April 5, 2007

Re: Draft Supplemental Environmental Impact Statement (DSEIS) for the Pinedale Anticline Oil and Gas Exploration and Development Project, Sublette County Wyoming

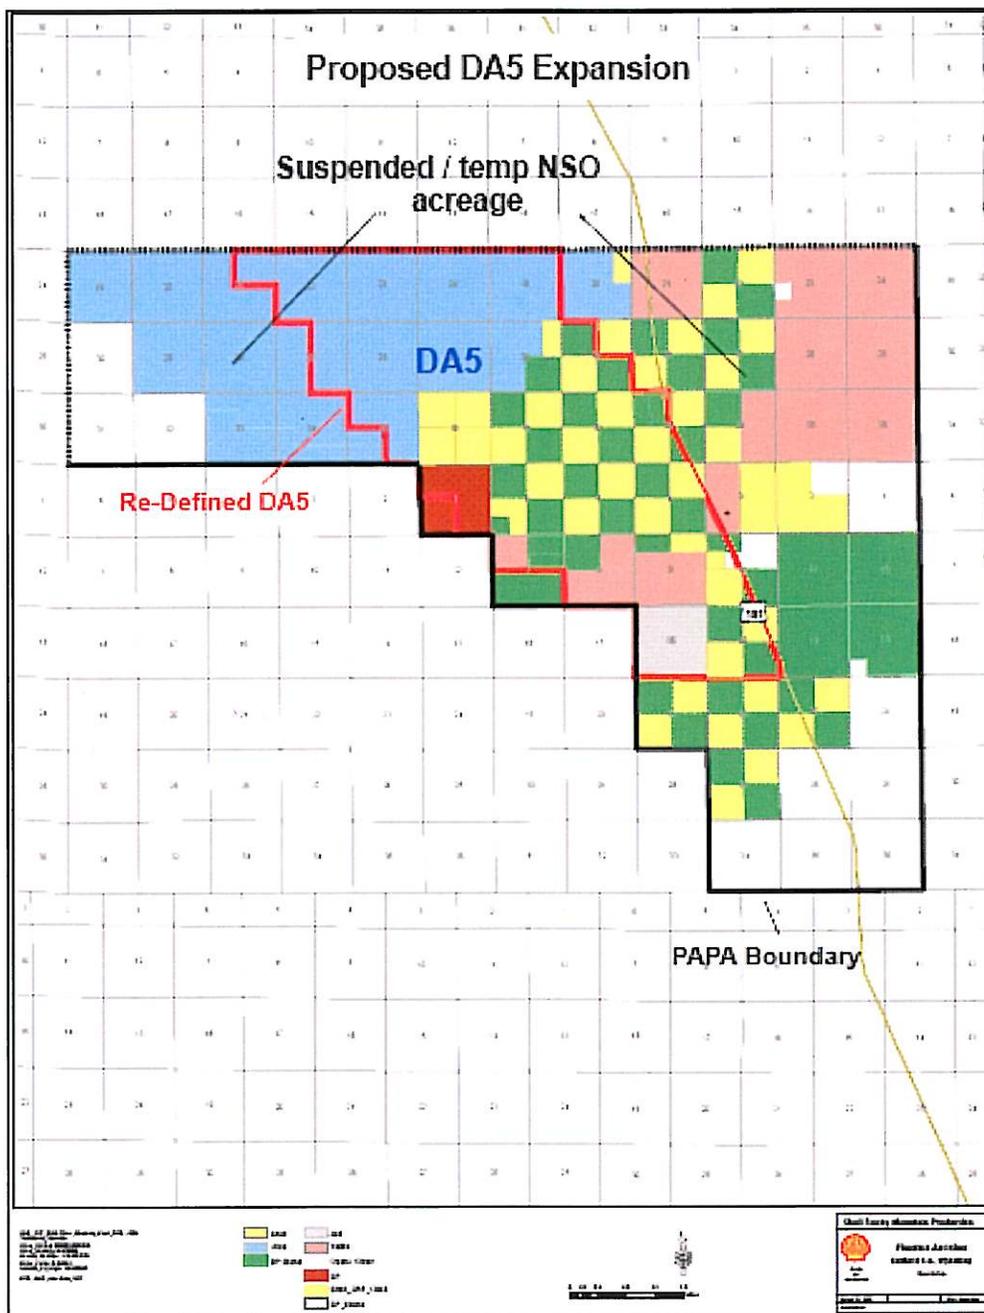
The Operators’ proposed modification of DA-5 extends the same concentrated development concept applied in the northern and central portions of the Pinedale Anticline to the southern end. Without the proposed modification, development in DA-5 and the surrounding area will continue under the management direction of the 2000 PAPA ROD with unconsolidated drilling across the entire area for a much longer time period. BLM has an opportunity, however, to minimize impacts by approving the Operators’ plan to consolidate drilling in DA-5 in exchange for Operator

commitments to preserve undisturbed large blocks of habitat outside the Core area. Modifying DA-5 will lead to less surface disturbance, less human activity, faster development and reclamation, and economical use of new environmentally-friendly drill rig technology. The Proponents support the Operators' proposed modification to DA-5, and ask that it be reflected in the FSEIS and ROD.

For BLM's convenience, Proponents have included a map depicting the proposed core development area within the PAPA, which also illustrates the half-mile buffer designed to provide additional mitigation measures and surrounds all of the DAs. To reflect more accurately the core development area and the half-mile buffer, Proponents request that BLM use the Proposed Core Boundaries of DAs with Half-Mile Buffer Map provided below and adopt it in the FSEIS and ROD.

To depict the proposal in more detail as explained above for DA-5, Proponents have included the following map on DA-5. Proponents request that BLM use the Proposed DA-5 Map provided below and adopt it in the FSEIS and ROD.

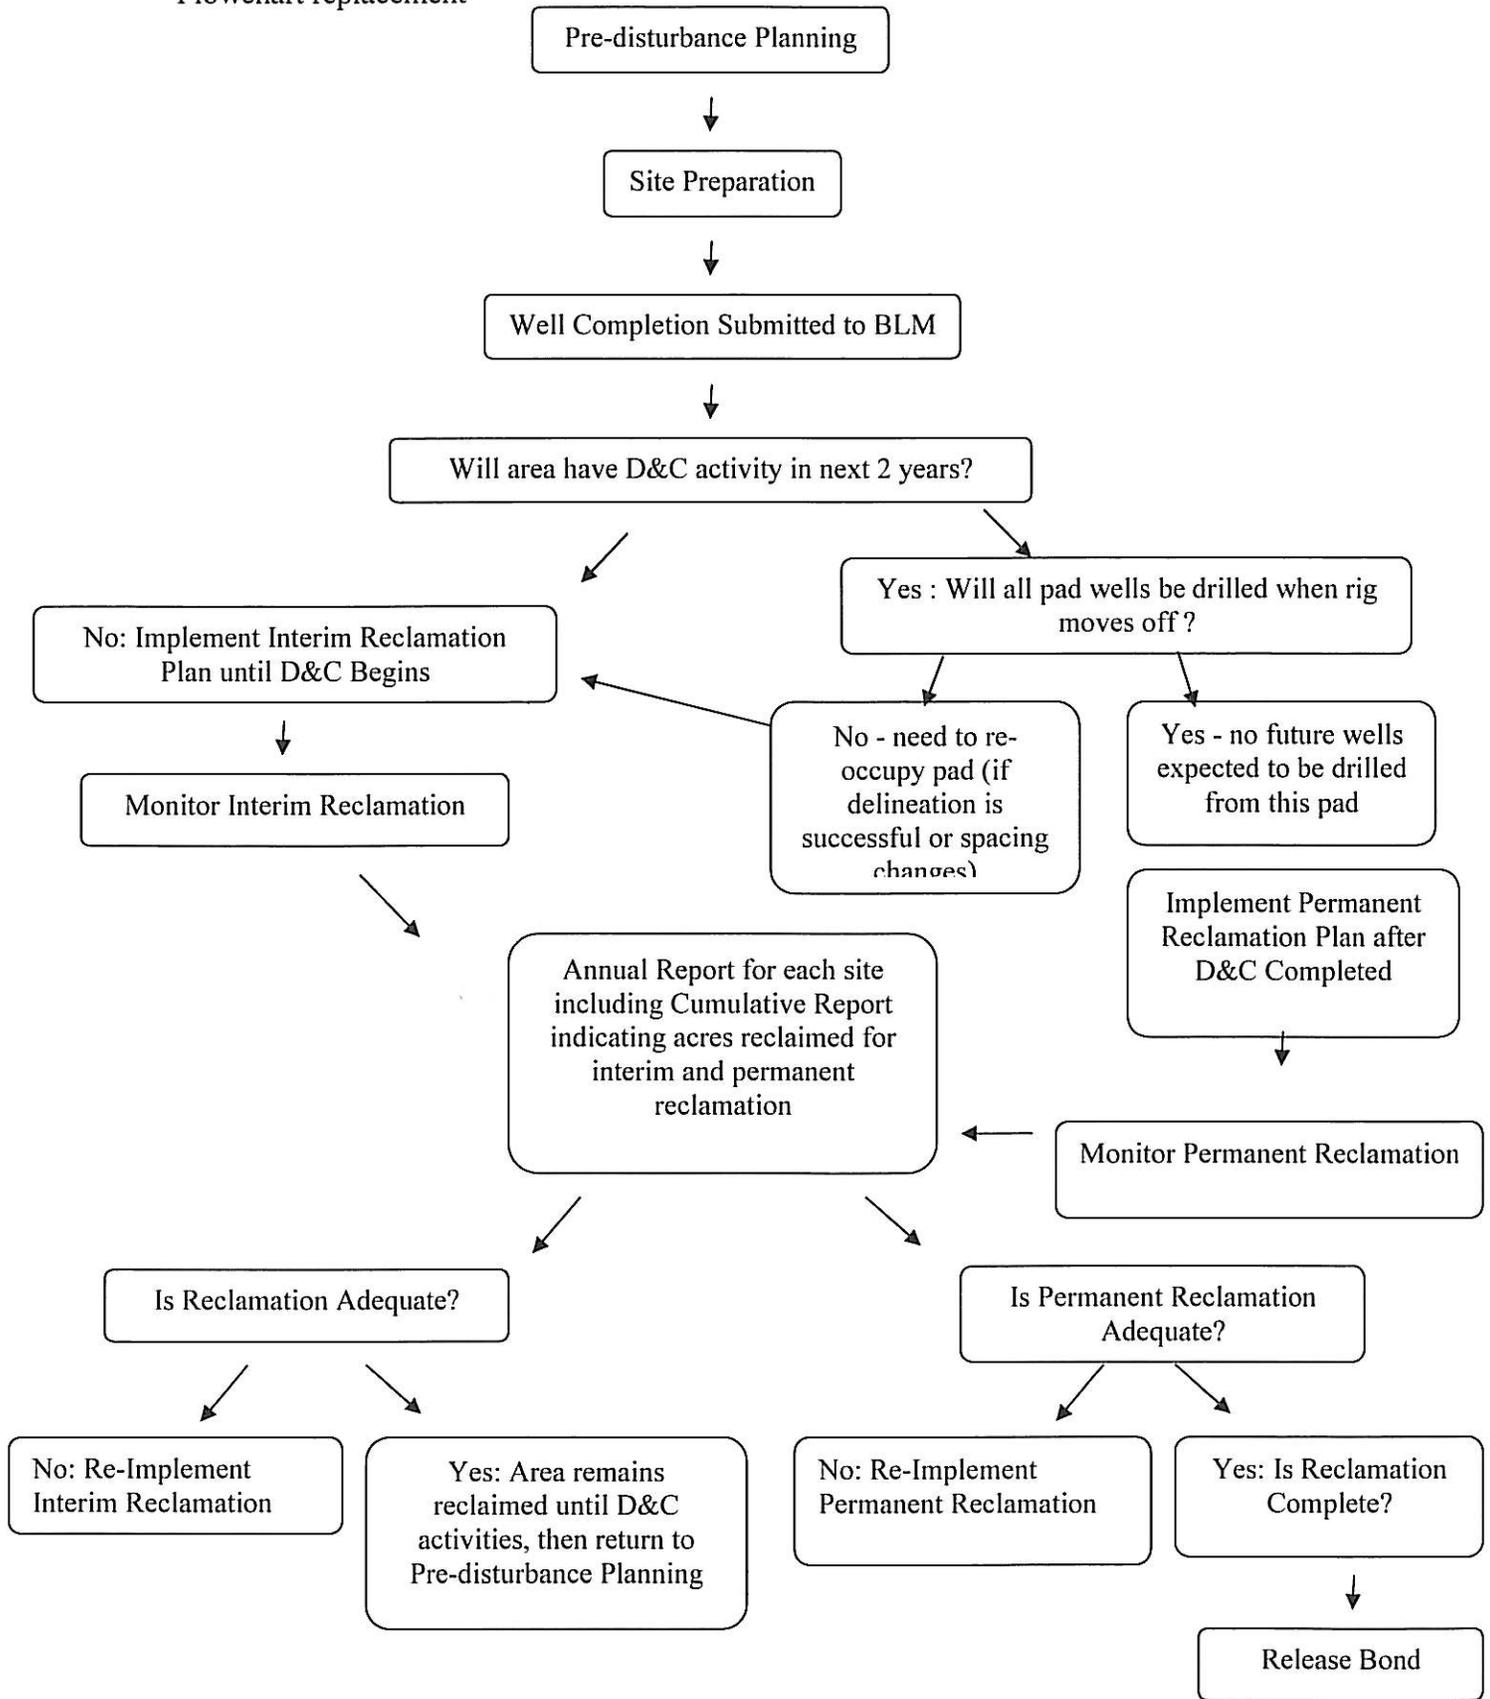
— G-20 —
— BI-1-222 —
The planning process described in Volume 2 of 2, Appendix E, p. E-1 through E-2 should be replaced with the ten-year rolling plan, fine tuned in annual multi-agency meetings as described in the Proponents' General Section, pp. 26-27. Rationale for using the longer-term planning process with annual meetings to assess operations, review monitoring information and adjust operations as necessary is explained on those pages and the Performance Based Planning needs to define this process as outlined.

— G-21 —
— BI-1-223 —
Under "Planning" on p. E-2, the phrase, "... Operator(s) would not reinitiate development on the pad...,contradicts the intent of adaptive management planning that Performance Based Objectives are based on and should be deleted and replaced with language cited and explained in the Proponents' General Section, pp. 22-23,,: "*Pads will be reused expanded to the extent possible. Pad issues will be discussed and resolved in annual planning with the BLM and Game and Fish .*"
